**BIODIVERSITY NET GAIN – RIVER METRIC process – step by step flow chart exercise**

# BIODIVERSITY NET GAIN – RIVER METRIC process – supplementary information

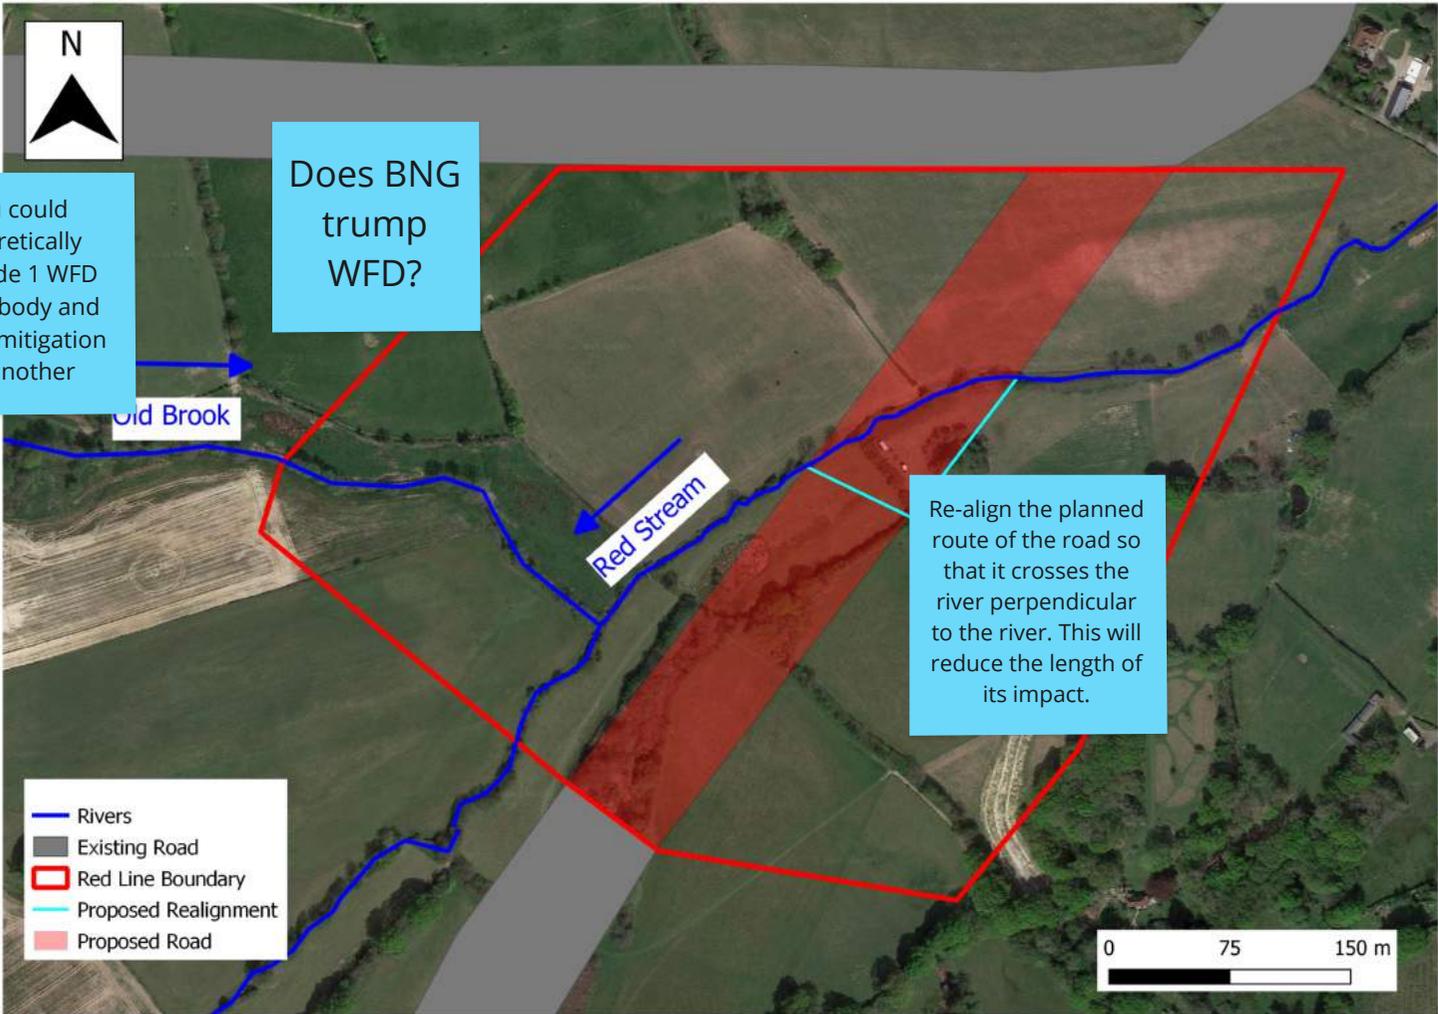
You could theoretically degrade 1 WFD water body and put all mitigation on another

Does BNG trump WFD?

Re-align the planned route of the road so that it crosses the river perpendicular to the river. This will reduce the length of its impact.

You need more vegetation, more shade to the water, add meanders.

Bridge for the road?.. or maybe a culvert under the red stream for the road?

The Red Stream diversion needs to be more diverse in terms of geomorphology and habitat, e.g. add meanders, more in-stream features, backwaters, ponds, native tree planting

Remeander section of Red Brook

Build viaduct over river

Sediment management south of Old Brook - riparian buffer (native species)?

Location of red line boundary is crucial

Realignment of proposed alignment

Alter the proposed Red Stream culvert design to a wide open span bridge, retaining natural banks

Restore Old Brook to its floodplain, including backwaters, ponds, native tree planting

Can the road be elevated above the river so a culvert isn't required. Shading would still be a problem, but less enhancements would be required to mitigate

Can the road go in a tunnel underneath the river retaining the floodplain and river

Concentrate on Old Brook? Fairly poor.

Use local knowledge, existing data u/s and d/s

INNS  
management  
on both  
streams

In stream  
features  
old brook

Wetland  
creation

Look off site  
for  
enhancements

Plant  
trees

Floodplain  
reconnection  
old brook
